**Vale
of White Horse**
District Council

Dalton Barracks Strategic Allocation Supplementary Planning Document Consultation Statement

March 2022

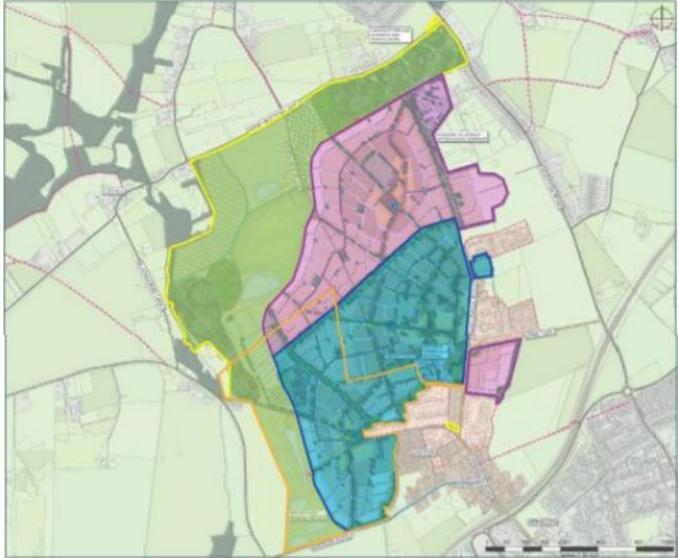
Name/ Organisation/ Comment ID	Category	Comment Summary	Officer Response	Proposed Modification
179465044 Abingdon-on-Thames Town Council	General	<p>Proposed development likely to have a significant impact on Abingdon in terms of roads, public transport, education, local services and businesses and all aspects of life for both communities.</p> <p>Currently major developments being built to the north of the town. Hope to work constructively with the planning authority and the developer to ensure that the needs of existing and new residents are met.</p>	Noted.	
179465044 Abingdon-on-Thames Town Council	Access and transport	<p>Town Council objectives relating to the proposed development:</p> <ul style="list-style-type: none"> • developing and encouraging active travel; • ensuring that the new community is properly connected to surrounding communities, including Abingdon via good pedestrian and cycling routes and reliable public transport; • ensuring that children and young people who wish to travel to schools and to the college in Abingdon can do so safely. 	<p>Noted.</p> <p>Part 5 of the SPD (Paragraph 5.49) and bullet 1 of SDR4 require the developer to make the necessary contributions to implement sustainable transport initiatives, including minimising car usage and increasing the use of public transport, walking and cycling. Bullets 2 and 3 of SDR4 also require the developer to design a development that prioritises walking, cycling and public transport and provides a network of safe and attractive walking and cycling routes through the development and</p>

Name/ Organisation/ Comment ID	Category	Comment Summary	Officer Response	Proposed Modification
			connecting with the surrounding area, including through Shippon to Abingdon and cycle routes to Radley Station and Oxford.	
179465044 Abingdon-on-Thames Town Council	Education	Specific areas to note are the expected increase in the number of children and young people attending schools and college in Abingdon The Town Council would also request that consideration is given to the educational needs of the new community and that the expected contributions from developers at the site include funding for education in Abingdon to properly cater for the needs of these new students.	Core Policy 8b of the Local Plan requires the delivery of a mixed-use community incorporating on-site services and facilities including education provision. The Site Development Template requires a new two form entry primary school with nursery provision to be provided on site and contributions towards appropriate secondary school provision for the area in Abingdon-on-Thames.

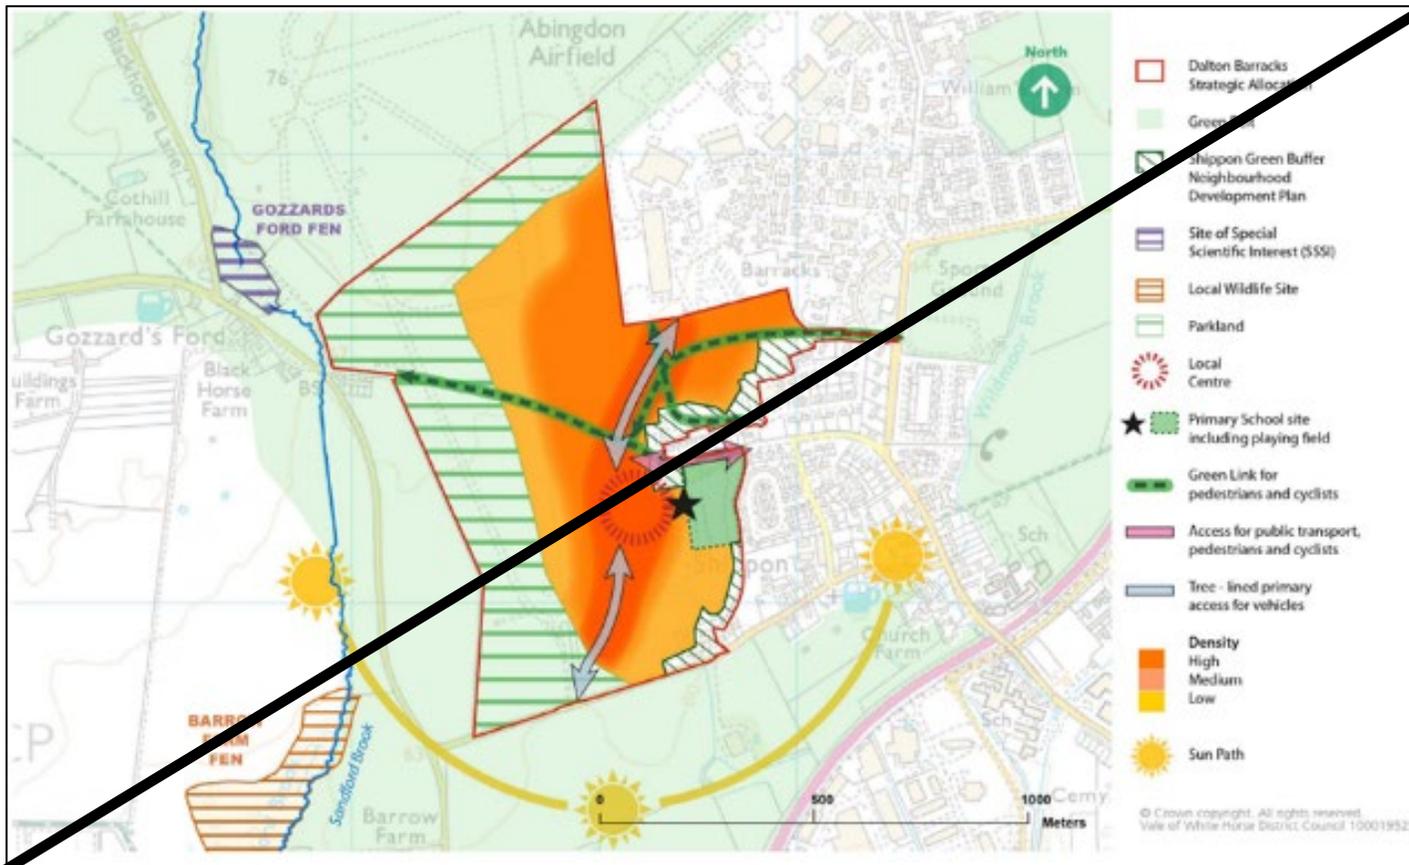
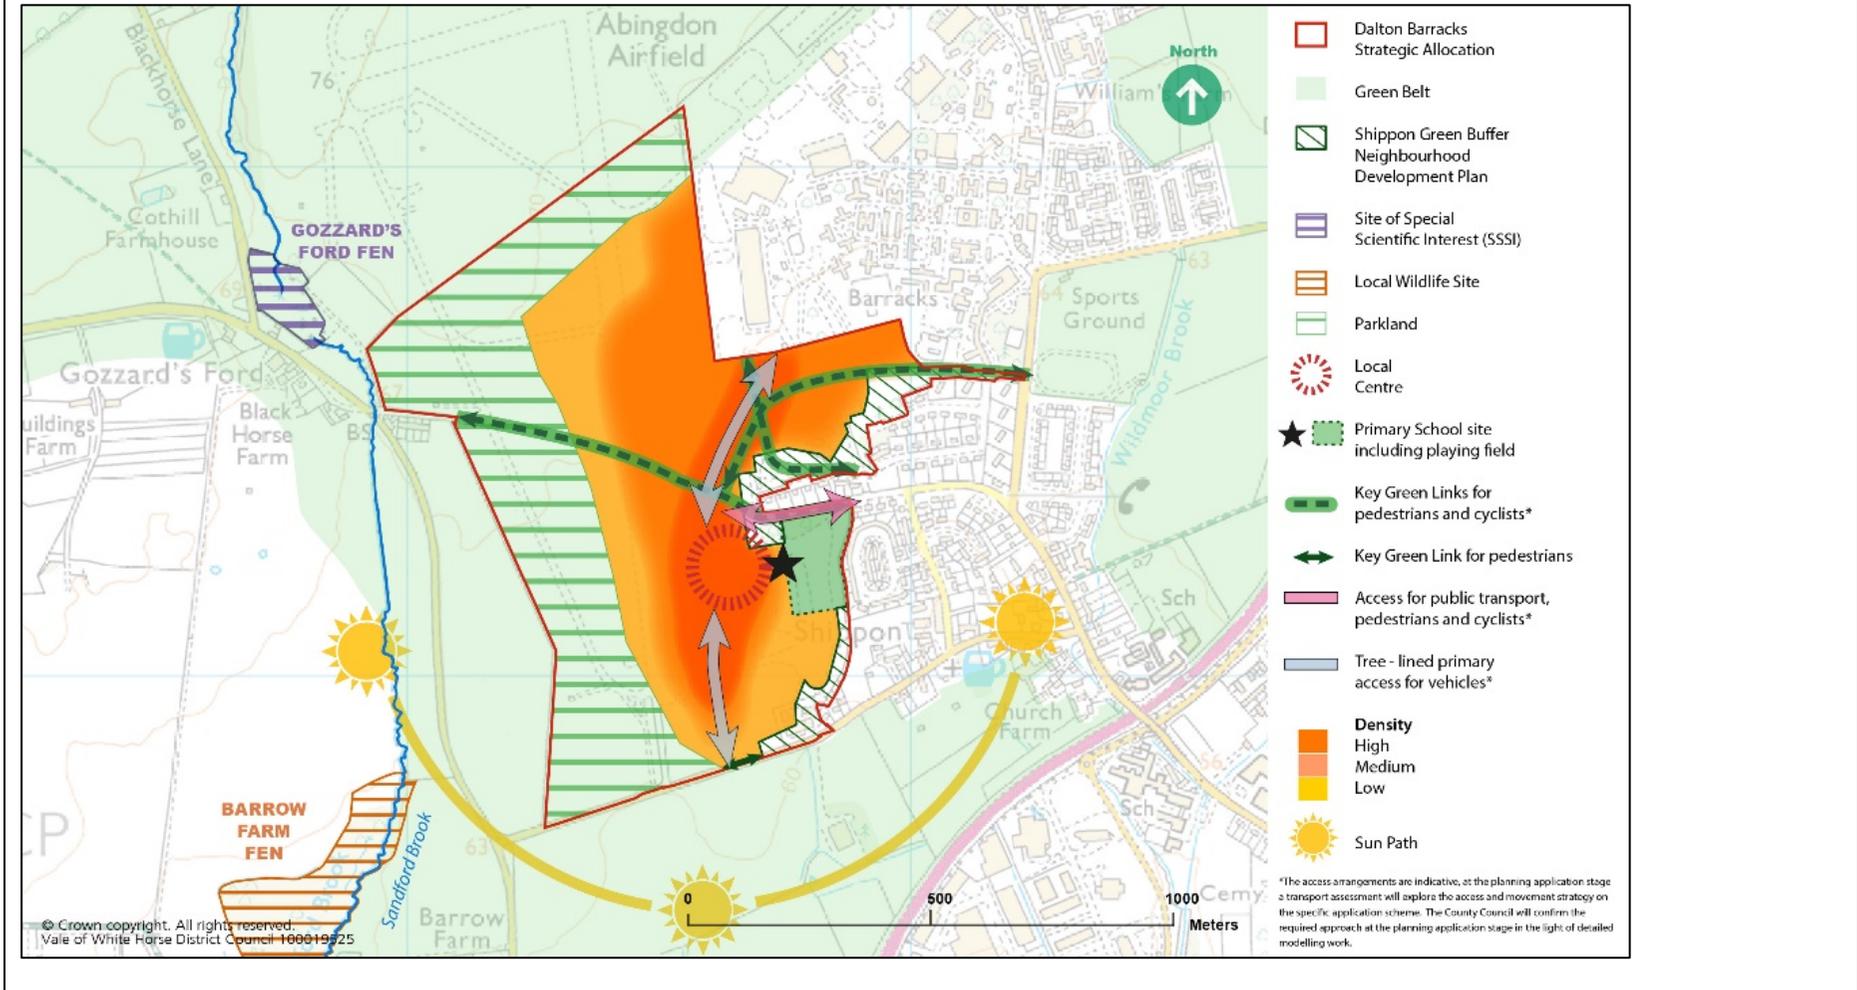
Name/ Organisation/ Comment ID	Category	Comment Summary	Officer Response	Proposed Modification
GL Hearn and Carter Jonas on behalf of Defence Infrastructure Organisation (DIO)		<p>Figure 5.2: Development Framework Map</p> 		
		<p>Fig 1 - Fig.5.2 Draft Development Framework Map – Dalton Barracks SPD – October 2021</p> <p>Fig 2 – DIO Proposed site wide masterplan showing the SPD Area and the proposed Outline planning application and potential future areas of development</p>

Fig 3 - DIO's alternative Development Framework proposed for the SPD, at Figure 5.2.

M84	5	69	n/a	Figure 5.2	Update the Development Framework Map (shown on the next page), as follows: <ol style="list-style-type: none"> 1. Amended alignment of the access from Barrow Road and make corresponding change to the densities, including reducing the density at the site entrance with Barrow Road. 2. Amend the map key: “<u>Key</u> Green Links for pedestrians and cyclists^{**}” 3. Add new pedestrian link next to Barrow Road and add to map key: “<u>Key Green Link for pedestrians</u>” 4. Add “^{**}” to the map key access elements, and add the following text: <u>“The access arrangements are indicative; at the planning application stage a transport assessment will explore the access and movement strategy on the specific application scheme. The County Council will</u>

Modification Number	Part	Page	Paragraph	Other reference	Proposed modification
					<u>confirm the required approach at the planning application stage in the light of detailed modelling work.”</u>

Draft SPD version

Proposed modified version:
